**DEFENSE NUCLEAR FACILITIES
SAFETY BOARD**

RECOMMENDATION 2019-1 TO THE SECRETARY OF ENERGY
Uncontrolled Hazard Scenarios and 10 CFR 830 Implementation at the Pantex Plant
Pursuant to 42 U.S.C. § 2286a(b)(5)
Atomic Energy Act of 1954, as Amended

NUCLEAR EXPLOSIVE OPERATIONS WITH UNCONTROLLED HAZARDS AT THE PANTEX PLANT¹

NUCLEAR SAFETY MANAGEMENT AT THE PANTEX PLANT¹

Figure 1. *Cracked Safety Catches in the W76 Aft Disassembly Fixture, 076-2-0382 [26].*

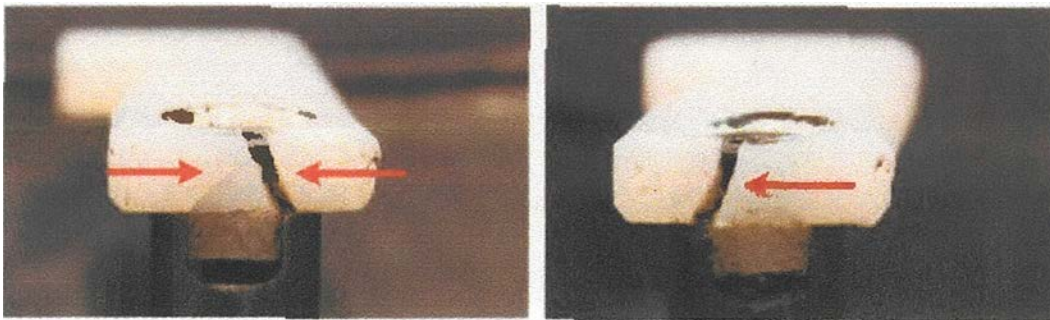
- *Safety Catches*—The staff review team evaluated the use of W76 vacuum lifting fixtures and the 2015 issue in which cracks were identified in vacuum lifting fixture safety catches (see Figure 1). The safety catches are a secondary feature to prevent a drop of high explosive charges should vacuum fail on the lifting fixture. The staff review team is concerned that actions taken to-date may not prevent recurrence of cracking of safety catches. Pantex continues to rely on production technicians to identify cracking during routine prior-to-use inspections. The staff review team believes that application of an ISI or introduction of a specific step within the nuclear explosive operating procedure to check for safety catch damage prior to use would bolster the reliability of this check. Alternatively, the safety catches could be redesigned, substituting a material with a lower likelihood of cracking (e.g., appropriately coated metal).
